## Global Change Notification (GCN)

Product Family	DuraClik™ (CRIMP REC. TERMINAL FOR 2.0W/B SMT)	10663202
----------------	--	----------

Series	560085	November 26, 2014
--------	--------	-------------------

Reason For Change	Change In Packaging Specifications
-------------------	------------------------------------

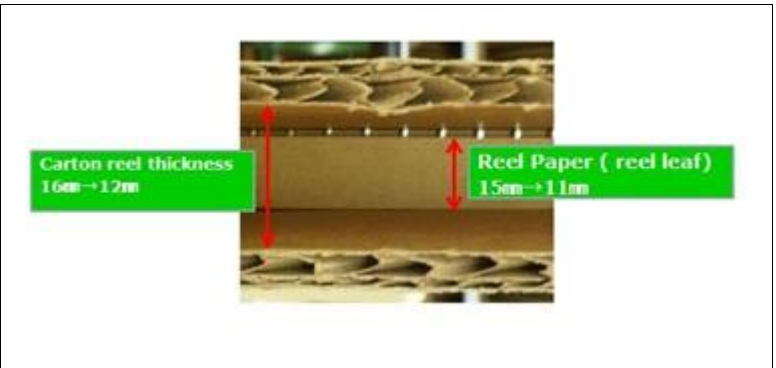
Change Description	This is a notification for a change in packaging of 560085-0101 terminal. Molex is to shorten plastic protection band width of the reel to reduce the clearance between terminals and packaging to improve protection during transportation of products. Also, Molex will tighten the reel tension for additional security during transportation, and for easier use of automated crimping process in our customers. Furthermore, the carton, reel, and kraft width will become shorter accordingly to the band width. There will be no influence on products function of 560085-0101, only package style is changing. The implementation date is scheduled on 1st Dec, 2014 (Might be changeable due to some arrangements for the change).
--------------------	---
